BNSF RAILWAY - UNION PACIFIC RAILROAD

GUIDELINES FOR RAILROAD GRADE SEPARATION PROJECTS

TxDOT Comments and Exceptions – October 24, 2007	
4.4.6 Vegetation	19
4.5 Drainage	19
4.5.1 Erosion and Sediment Control	20
4.5.2 Hydraulic Criteria for Bridge and Culvert Openings	20

FILE OWNER: UPRR DATE: 1/24/07
PLAN NO.: 711100 SHEET: 1
REVISED: 3/19/2007 2:58:49 PM

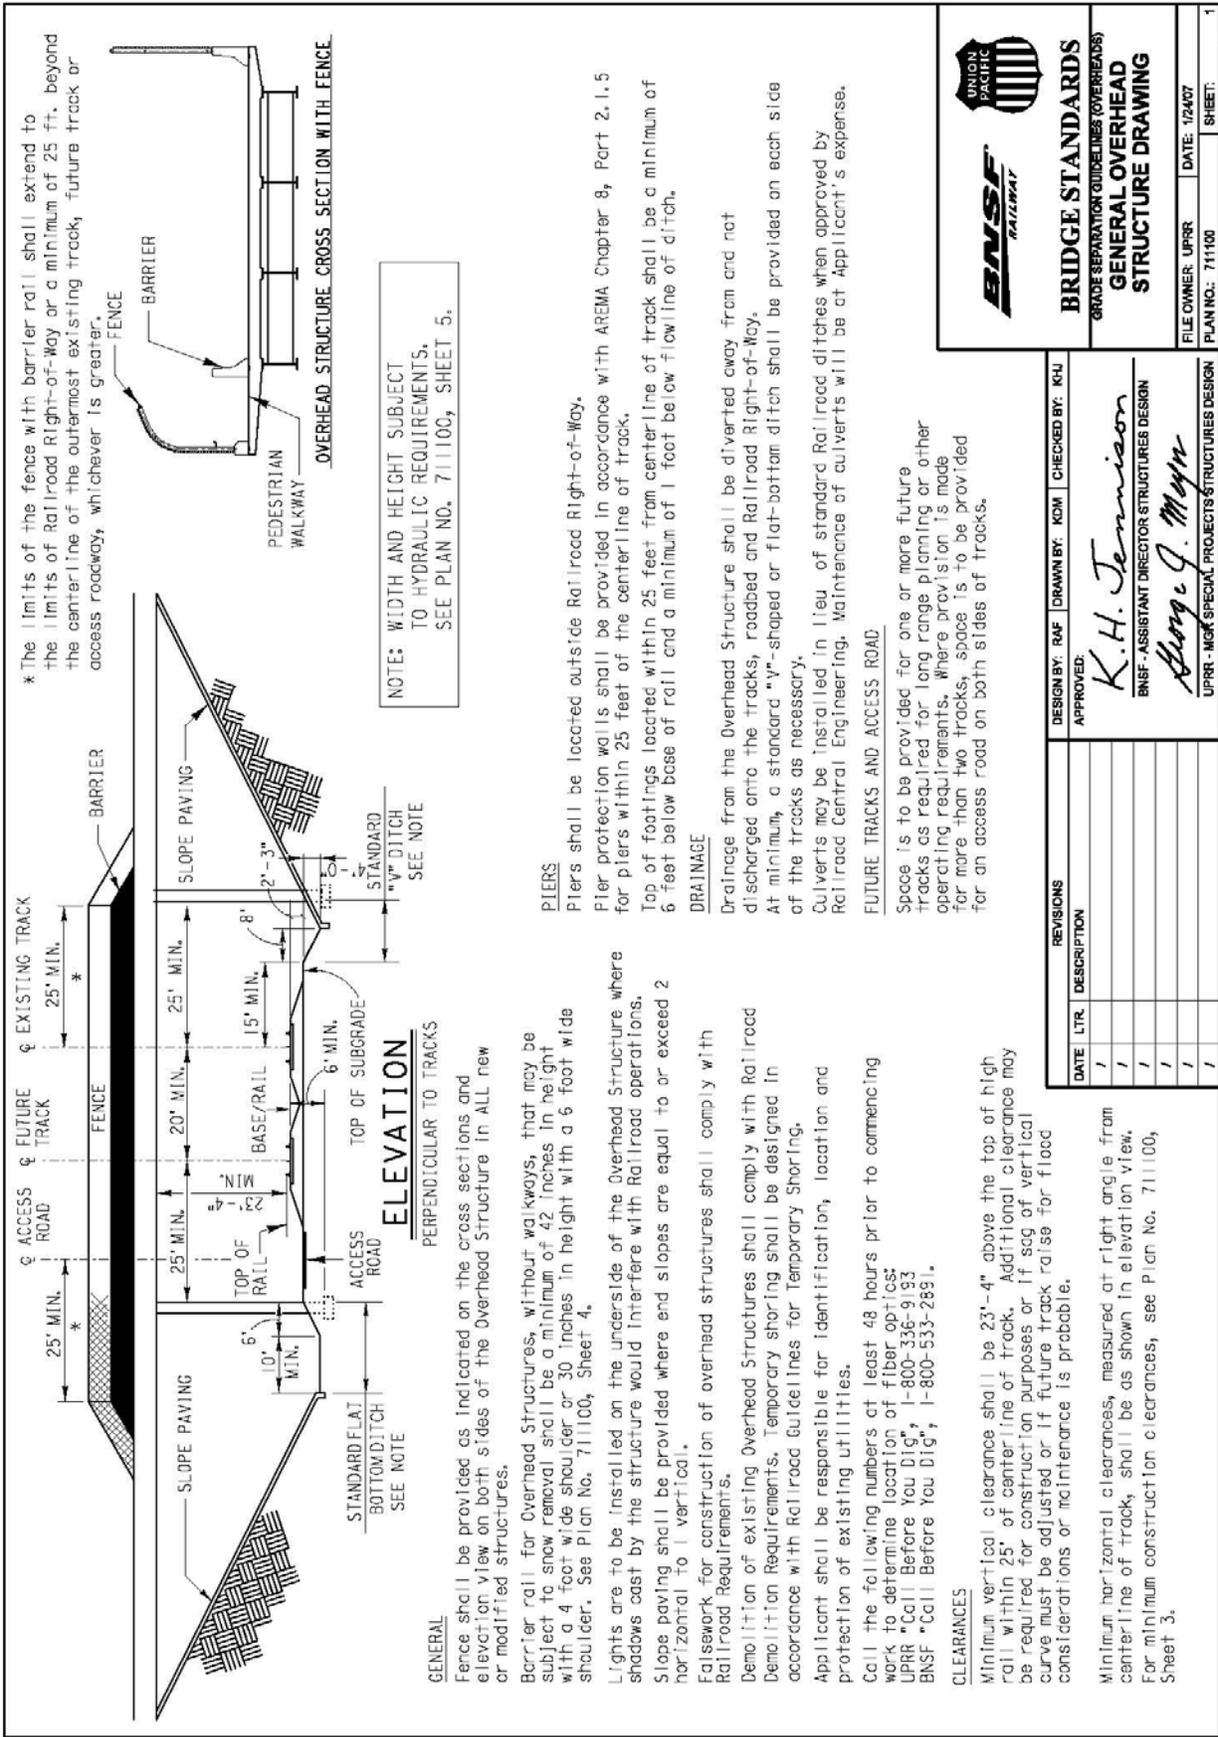
TxDOT Comment - The 23'-4" vertical clearance is a literal conversion of the metric requirement of 7.1 m in CFR Title 23 Highways, Part 646 Railroads, Appendix to Subpart B-Horizontal and Vertical Clearance Provisions for Overpass and Underpass Structures which is only reported to 1 significant digit. The intent of CFR Title 23 Highways, Part 646 Railroads, Appendix to Subpart B-Horizontal and Vertical Clearance Provisions for Overpass and Underpass Structures is 23'-0", which is the same requirement of AREMA 28.1.7. TxDOT will attempt to meet 23'-4" to provide additional margin, but only if this is at negligible additional cost.

TxDOT Comment - The railroad must provide an indication of the estimated future track raise (if reasonable) if TxDOT is to accommodate it.

TxDOT Comment - TxDOT will only provide margin for removal of sag if it results in minimal additional project cost.
